**TOWN OF NEWBURGH
PLANNING BOARD
TECHNICAL REVIEW COMMENTS**

PROJECT NAME: GARDNER RIDGE
PROJECT NO.: 2-29
PROJECT LOCATION: GARDNERTOWN ROAD NEAR GIDNEY AVENUE
SECTION 75, BLOCK 1, LOT 4.12
REVIEW DATE: 27 OCTOBER 2023
MEETING DATE: 2 NOVEMBER 2023
PROJECT REPRESENTATIVE: DARREN DOCE, P.E.

Re: ***Gardner Ridge***
Gardnertown Road
Section 75, Block 1, Lot 4.12

We are submitting twelve (12) copies of the revised Amended Site Plan sheets on behalf of Gardner Ridge Associates.

WORK ZONE TRAFFIC CONTROL
CREEK RUN ROAD SHORT TERM
CLOSURE DETOUR PLAN

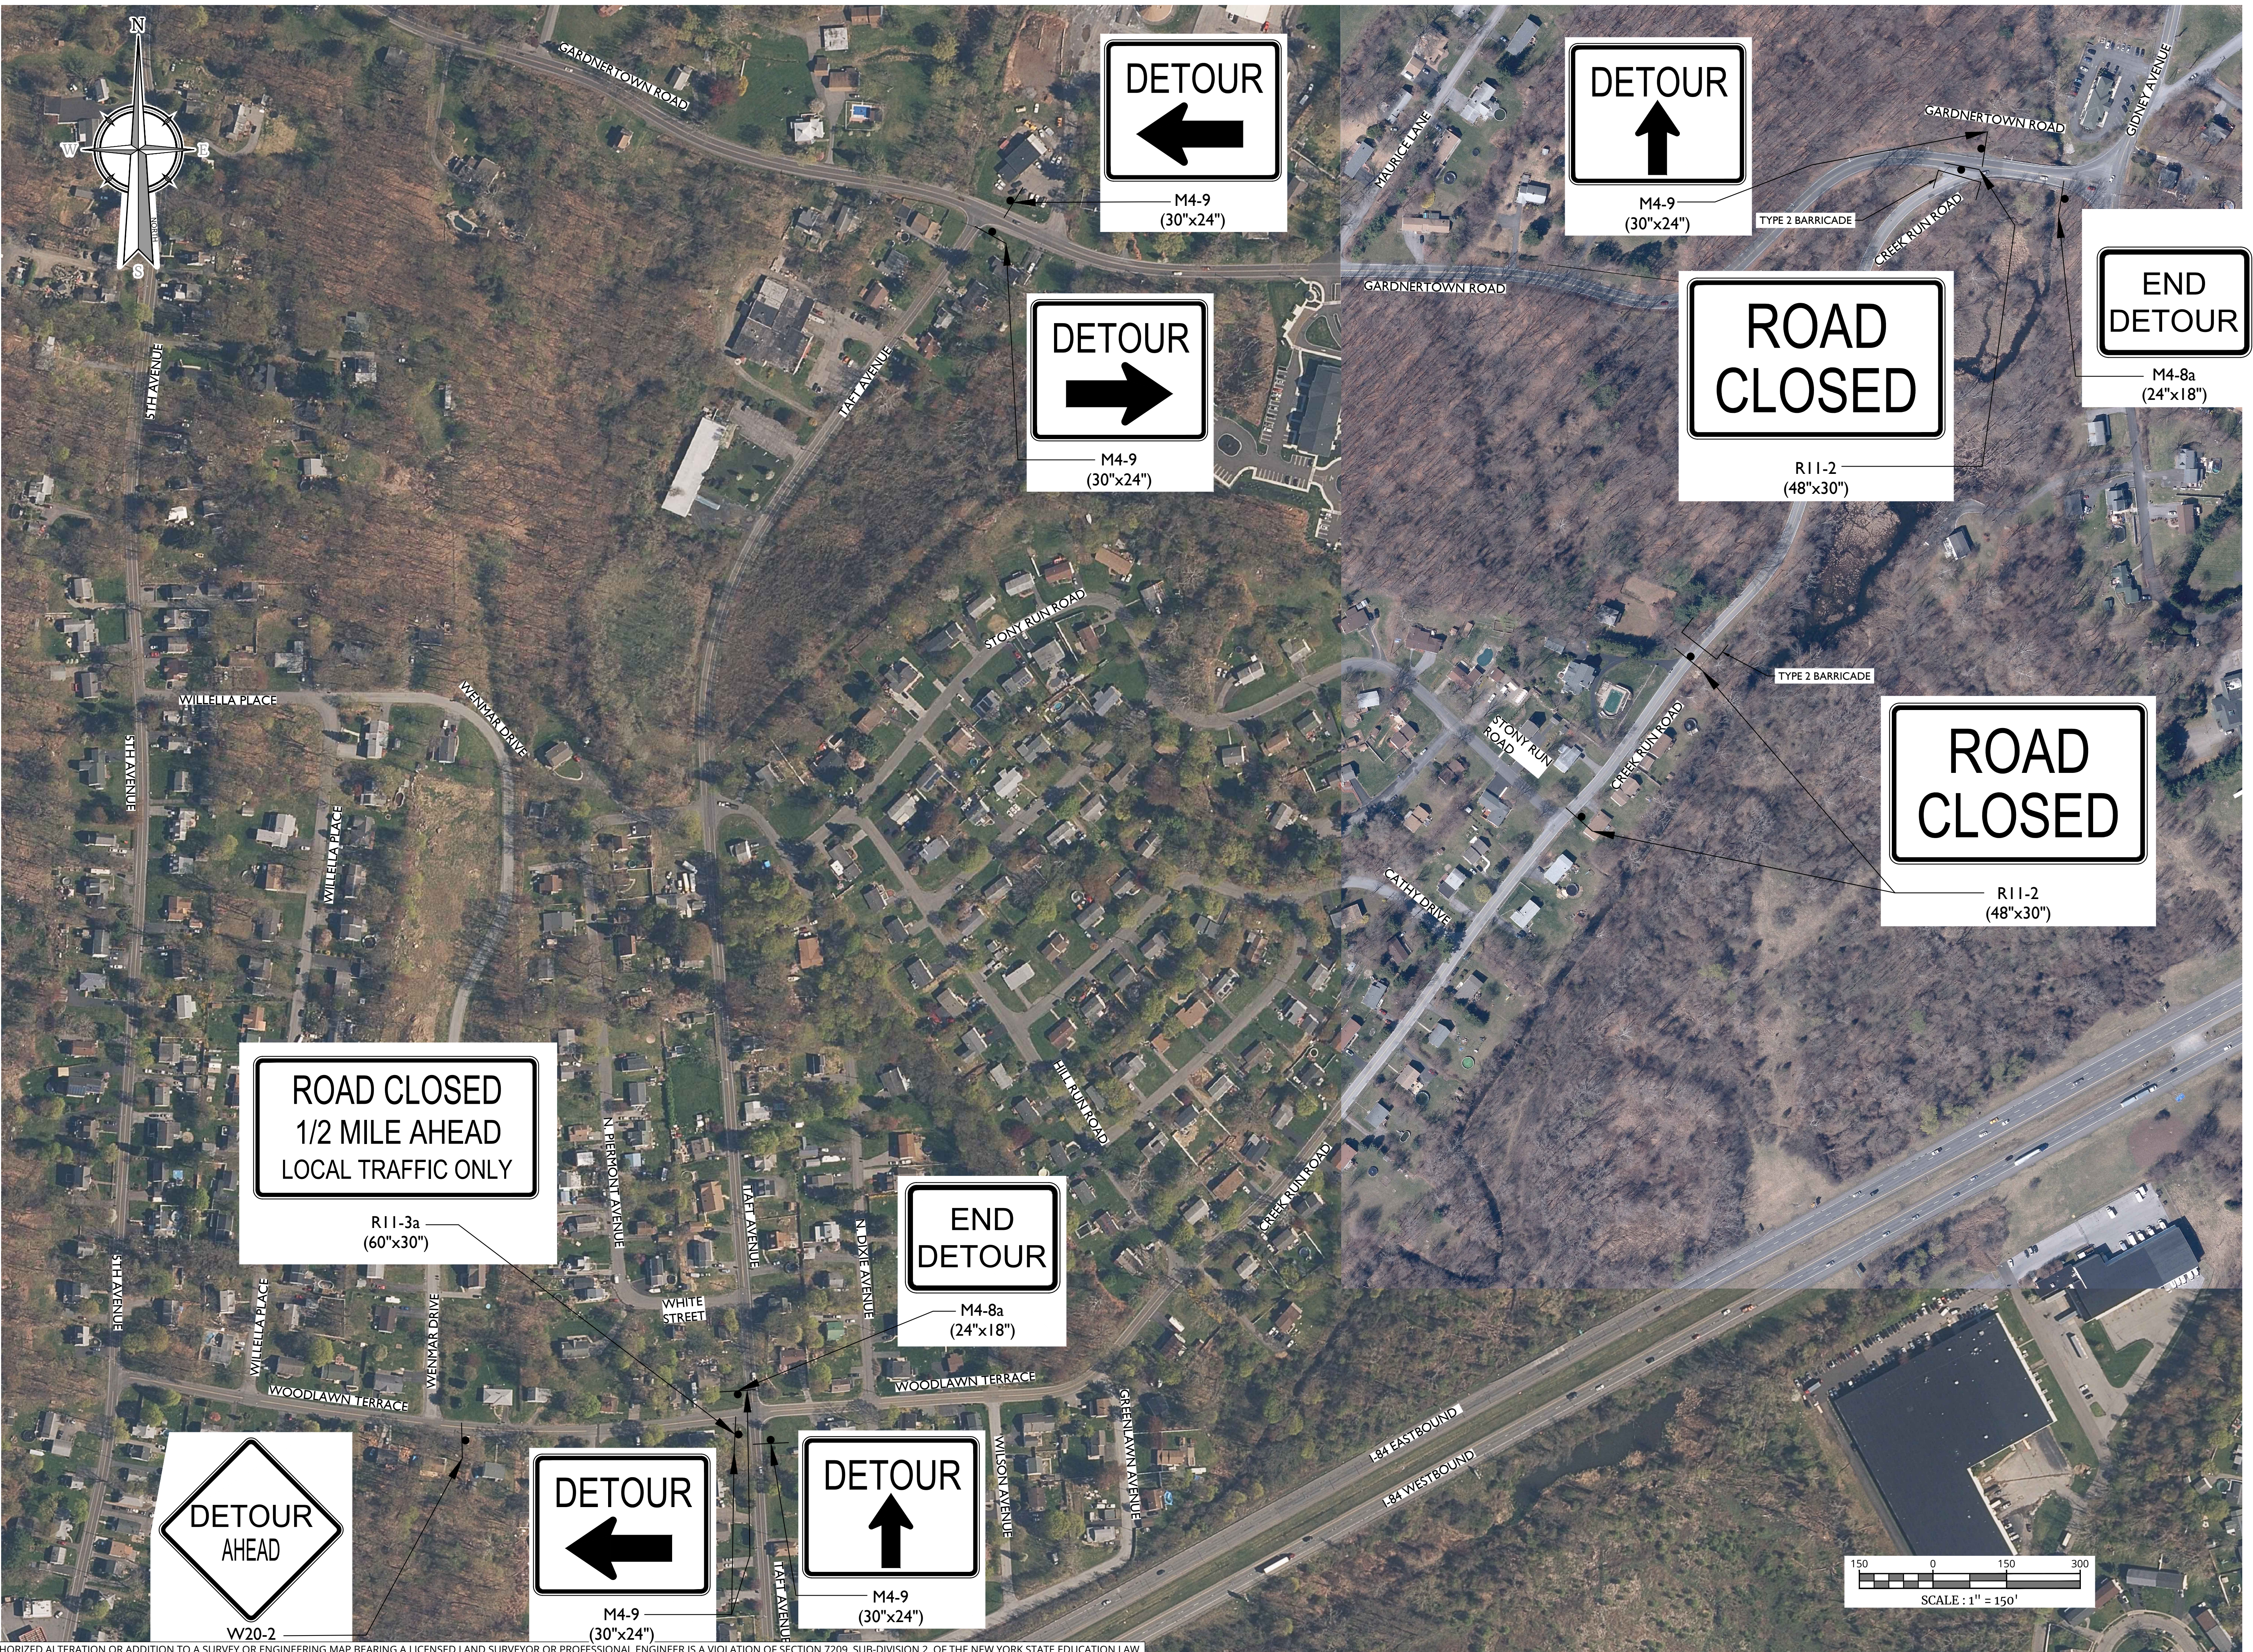
7. A detour plan is provided for when Creek Run Road is closed to be reconstructed between Stony Run Road and Gardnertown Road. What is the approximate duration of closure?

8. Taft Ave is the primary route for eastbound and westbound traffic on Creek Run Road. Road names should be labeled on the plan.

Response: Most of the work for the realigned Creek Run Road can be advanced while maintaining the existing roadway operation. The final work connecting the new portion of roadway to the remaining existing portion of Creek Run Road is expected to require a closure for less than a week to complete and open it again to traffic.

Response: Road names have been added to the detour plan.
